Planning Commission Staff Report

SUBJECT: PALM SPRINGS PROMENADE, LLC FOR THE FINAL DEVELOPMENT PLANS OF A PREVIOUSLY APPROVED PLANNED DEVELOPMENT DISTRICT FOR THE CONSTRUCTION OF A 6-STORY HOTEL ON BLOCK "C-1" OF THE MUSEUM MARKET PLAZA SPECIFIC PLAN / DOWNTOWN PALM SPRINGS RENOVATION PROJECT LOCATED AT THE NORTHEAST CORNER OF WEST TAHQUITZ CANYON WAY AND BELARDO ROAD, ZONE CBD (CASE 5.1290 PD-361).

FROM: Department of Planning Services

A4.1

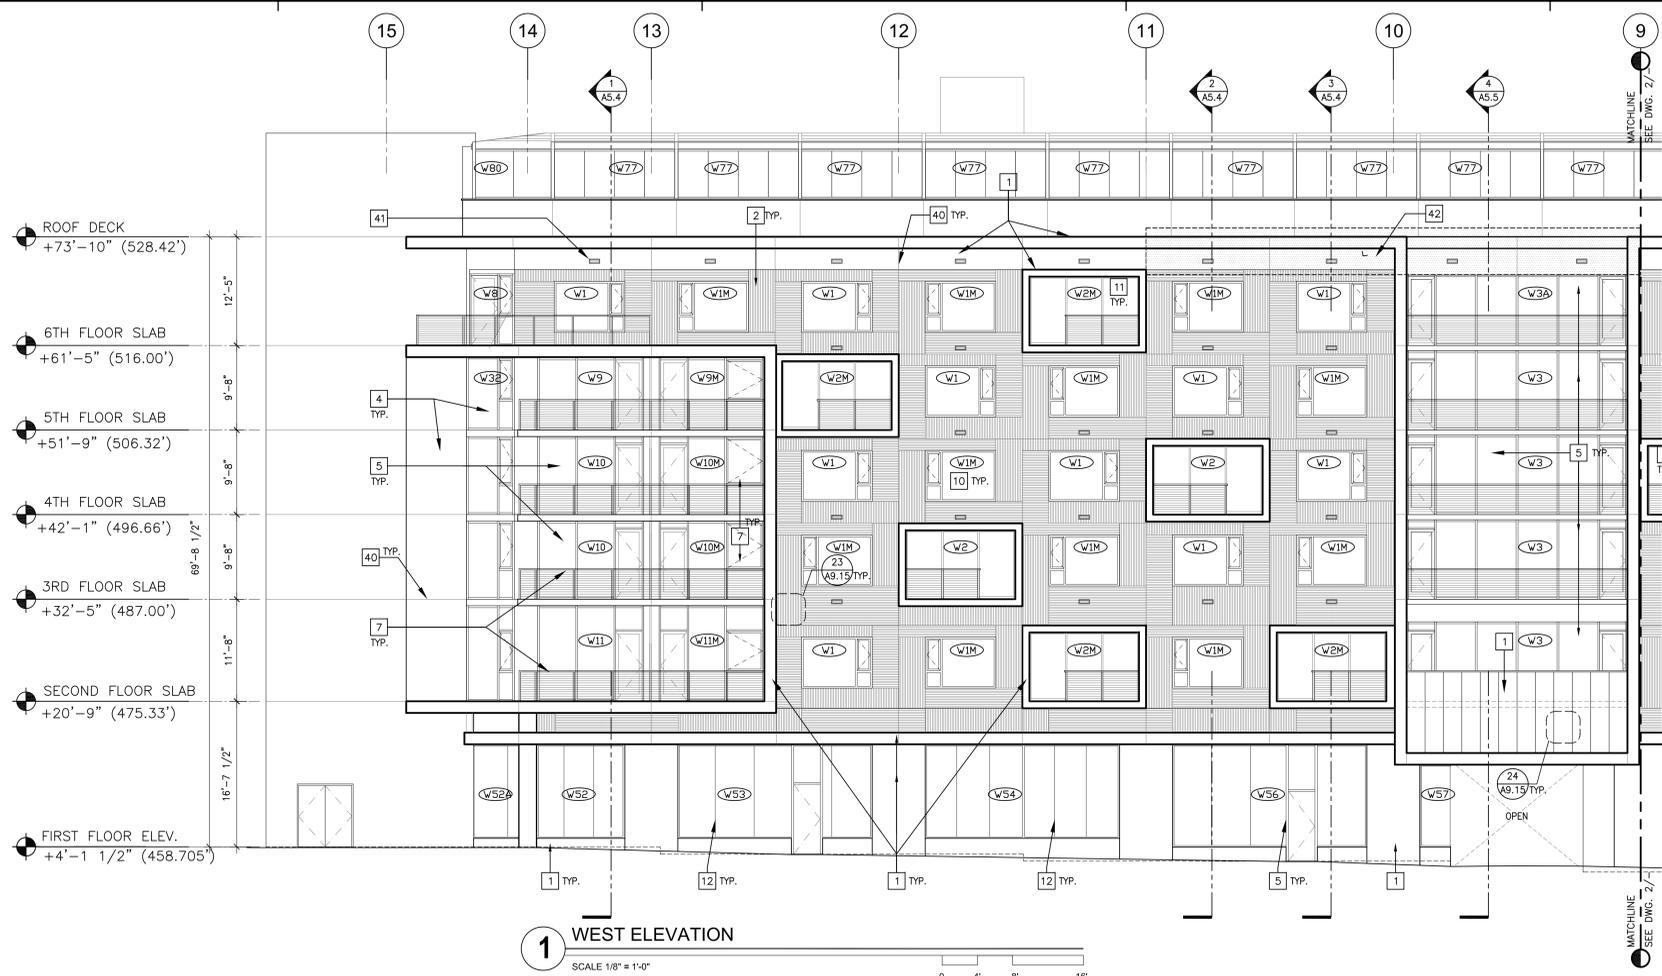
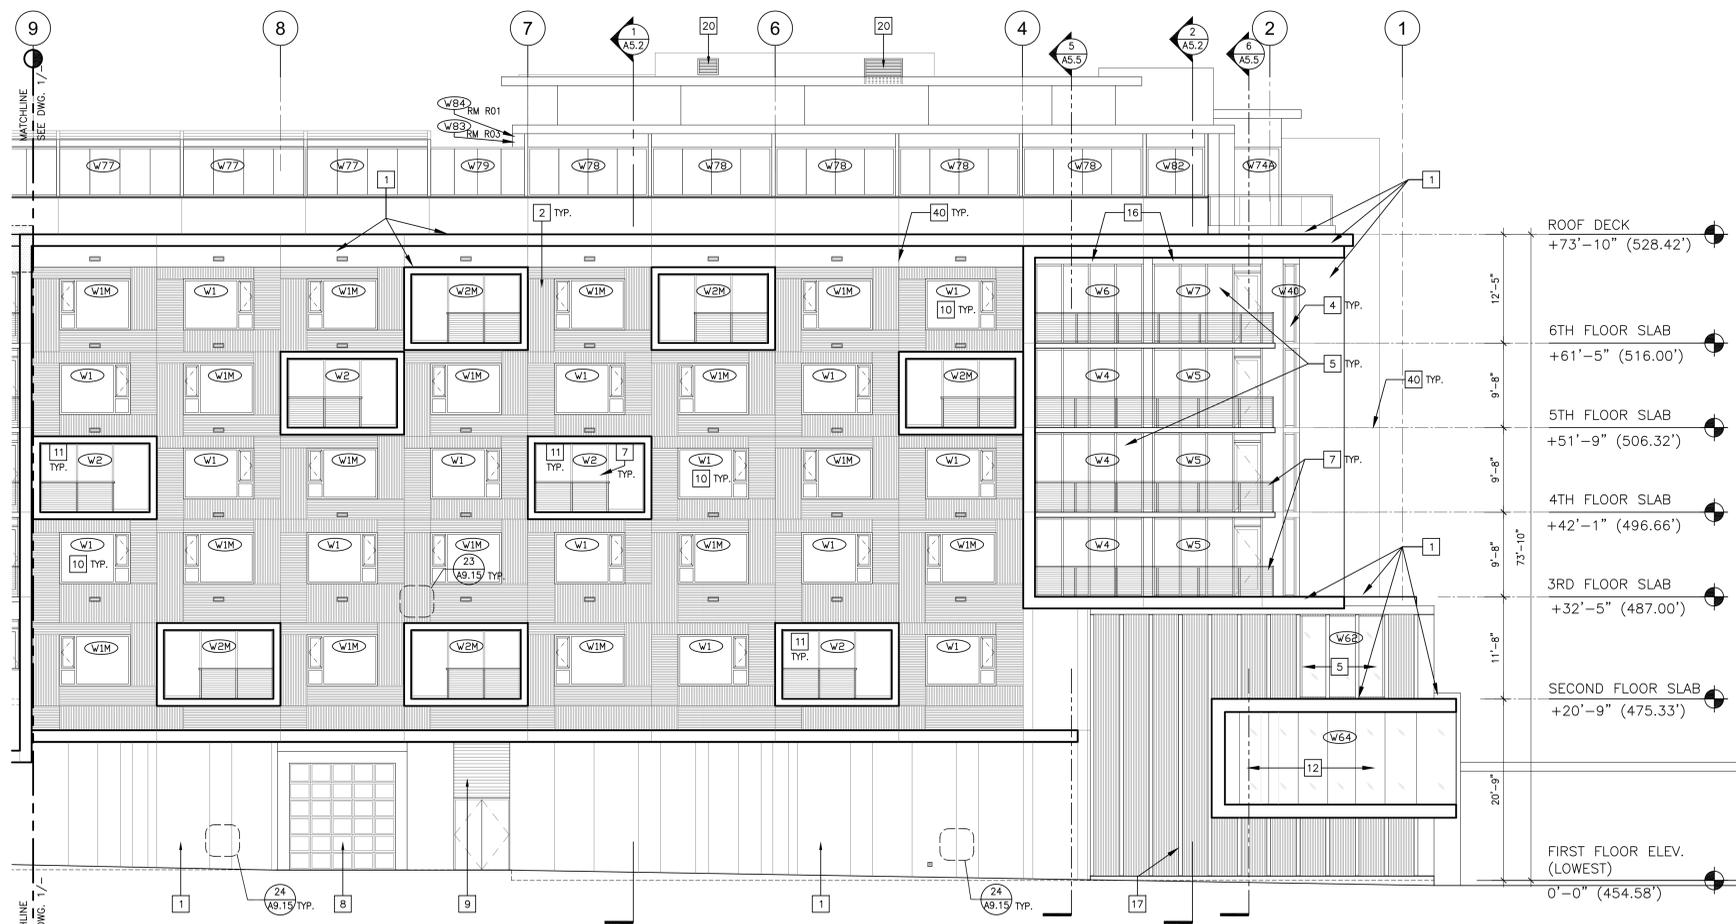
In response to item 1, the applicant has revised the west elevation to include additional vertical fins further north on the building (see attached Sheet A4.1); however, the fins do not extend the length shown in the Preliminary Development Plans. No additional changes are proposed by the Applicant.
